Determination 2010/64

Refusal to issue a building consent for an addition to a house with straw bale walls at 35 Loach Road, Wanaka

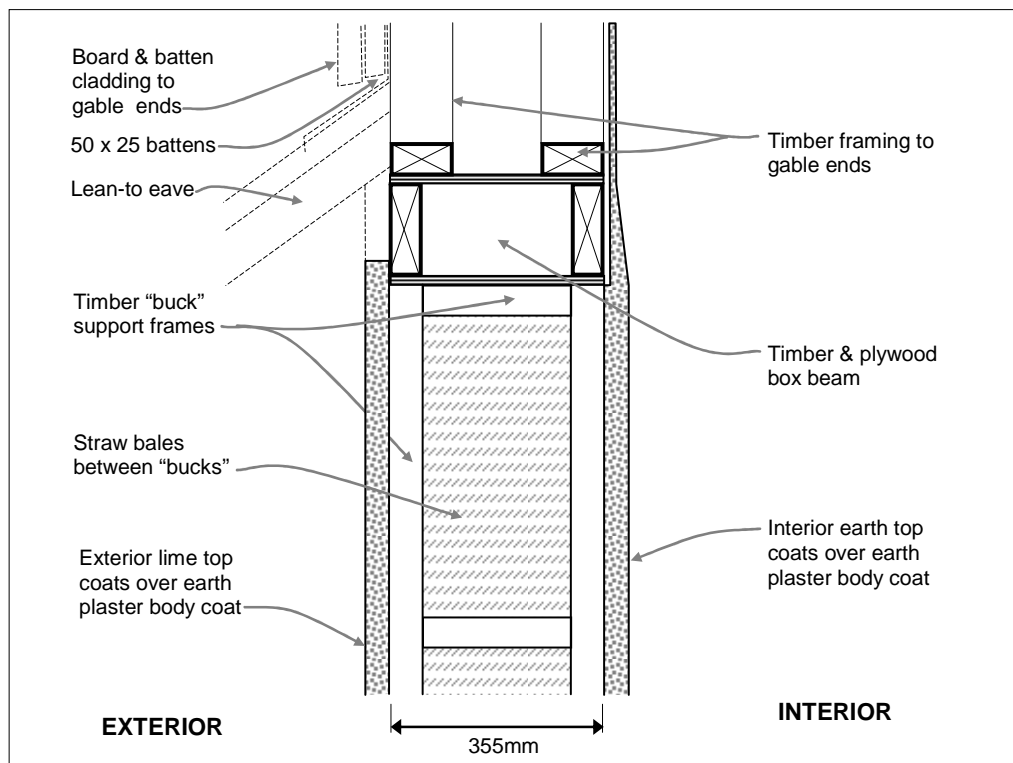
- 6.6.1 The specialist considered the roof overhangs shown in the original drawings, noting:
- the eaves and verges shown in the floor plan, the elevations and the eave details appear to be only 400mm wide, excluding gutters and fascias

- the gable end walls are particularly concerning, with regard to the verge projection and the junction of the upper cladding with the straw bale walls
- the verges are at a height of 5.4m at the ridge, so providing almost no protection to the straw bale walls
- the detail of the junction between the board and batten gable end cladding with the straw bale wall is not weatherproof and is likely to result in leaks
- the boards do not include weathergrooves.

6.7.2 In response, the designers revised the inter-cladding junction to show the battens behind the board and batten cladding increased in depth, with a projecting timber 'sill' at the base and a flashing extending over the top of the plaster. The boards are also now shown with weathergrooves aligning with those in the battens. (I note that

the revised details of 11 May 2010 have added a lean-to awning eave to the gable-end walls, making the earlier inter-cladding detail redundant).

- 7.3.2 The drawings considered by the specialist and during the preparation of the first draft determination showed little protection to the lower walls due to the height of the gables (see paragraph 6.7.1); and I concluded that additional protection was needed for those areas. In response to the draft determination the designers revised the gable ends to incorporate a lean-to 'canopy eave' at the inter-cladding junction, which provides the same shelter to the straw bale cladding as the other eaves.
